**ITEM FOR ENVIRONMENTAL BOARD AGENDA**

**NAME & NUMBER OF PROJECT:** AVERY STATION PRELIMINARY PLAN C8-07-0043.01

**SUBJECT:** Avery Station Subdivision Preliminary Plan – C8-07-0043.01

**Variance Request:** Variance from LDC 25-8-341 – To allow cut in excess of 4 feet but not to exceed 12 feet within a Suburban Watershed

**AVERY STATION  
SITE PLAN**

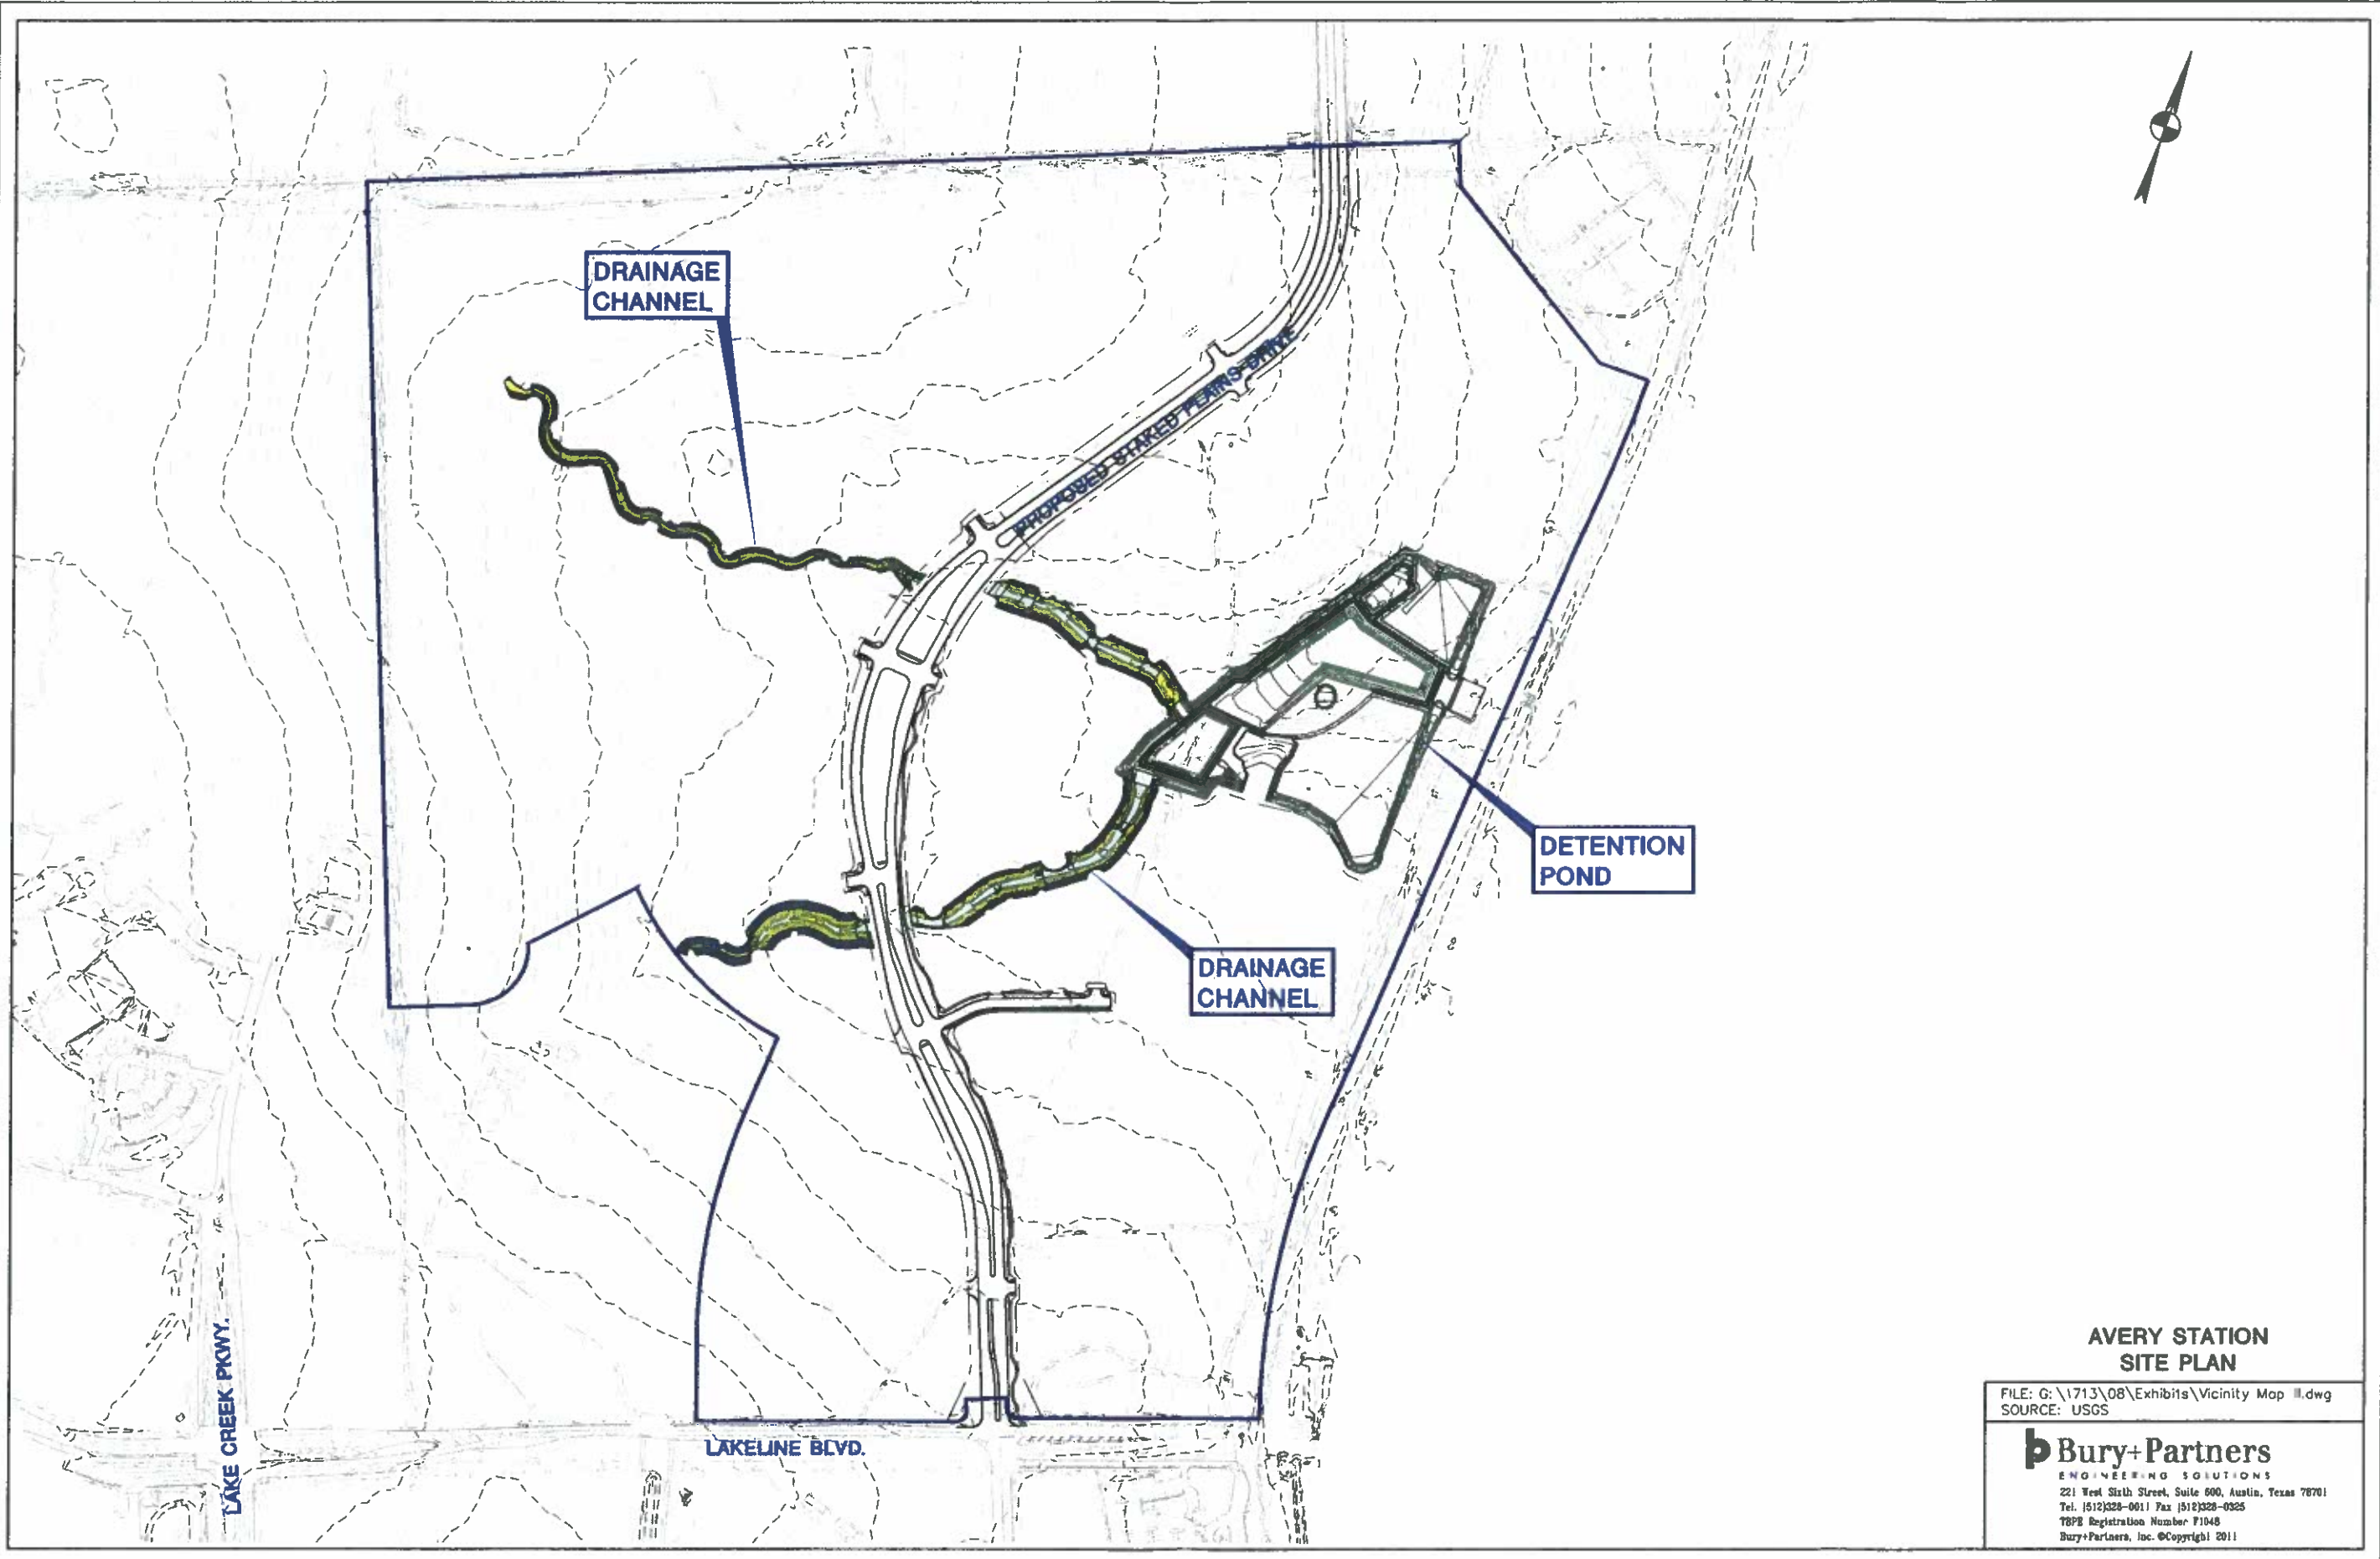
Please accept this letter, attached exhibit and finding of facts as our formal request for a non-administrative variance to Section 25-8-341 of the City of Austin Land Development Code, for cut over four feet (4'). We are proposing to cut over four feet (4') within Block 12, Lot 4; Block 1, Lot 3; Block 2, Lot 19; and Block 11, Lot 2. All of these lots contain drainage channels that convey stormwater to the regional wet pond serving the Avery Station Subdivision.

We are proposing to cut up to four to twelve feet (4'-12') in the channel areas as delineated on the attached exhibit. The depth of the channels is controlled by several factors which prevent a shallower channel section.

1. The site is conveying off-site drainage areas of 25 and 57 acres which require 48"-54" RCP for ultimate conveyance. The upstream depth of the channels starts at an elevation of seven to eight foot (7'-8').
2. The channel was the minimum slope requirement listed in DCM 6.4.1C. If a flatter slope was available, the channel depth could be reduced only downstream, near the pond.
3. The 100-year Hydraulic Grade Line is the third reason for the depth of the channels. A decrease in depth would result in the 100-year HGL being unable to be contained within the Right-of-Way.

This variance is recommended for consent; the findings of fact have been met. Staff recommends approval of this variance with the following conditions:

1. No concrete pilot channels will be constructed within the proposed drainage channels.
2. 609S.5 seeding is required within the channel bottom.
3. Channel slopes will be constructed with natural materials. Concrete walls will not be permitted except as necessary to preserve existing specimen trees along the channel.
4. As part of the preliminary plan submittal, the applicant will provide channel drainage calculations that demonstrate a sufficiently high roughness coefficient (Manning's n value) that will support the growth of dense herbaceous material and woody plants.
